PRODUCT/PROCESS CHANGE NOTICE (PCN)

PCN #: L-0607-01R1	DATE: 6-Oct-06	MEANS OF DISTINGUISHING CHANGED DEVICES:
Product Affected: Please see the attached list of the affected products shipped in tape and reel, and in tubes		<input type="checkbox"/> Product Mark <input type="checkbox"/> Back Mark Lot shipments will have Level 1 <input checked="" type="checkbox"/> Date Code Moisture Sensitive Label, and with <input type="checkbox"/> Other date code starting "0630".
Date Effective: 6-Oct-06

ATTACHMENT 1 - PCN #: L-0607-01R1

PCN Type: Change in Moisture Sensitivity Level

From: MSL 3 Moisture Sensitive Label

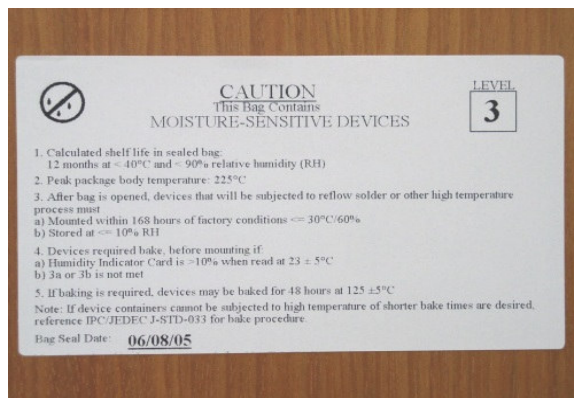
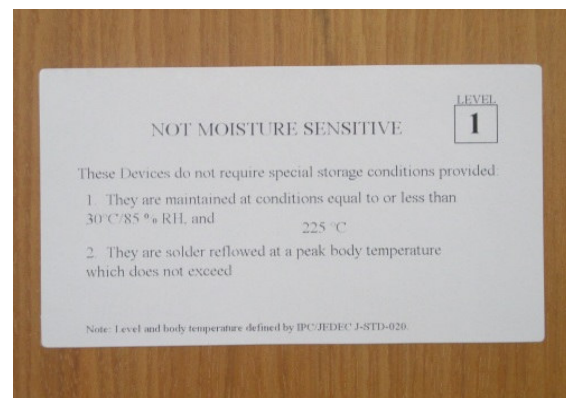
Data Sheet Change: There is change in Moisture Sensitive Level (MSL) from 3 to 1.

This notification is to advise customers that IDT is converting ICS MSL 3 products shipped in tape and reel, and in tubes, to MSL 1. IDT has completed the verification of the moisture sensitivity classification of ICS products to MSL 1.

The affected products will be shipped without dry pack and labelled as MSL 1 according the JEDEC J-STD-033. There is no change to the assembly material set and the peak reflow temperature. Please refer below for the examples of moisture sensitive labels.

To: MSL 1 Non-Moisture Label

Note: There is no change to the peak reflow temperature of the affected products.
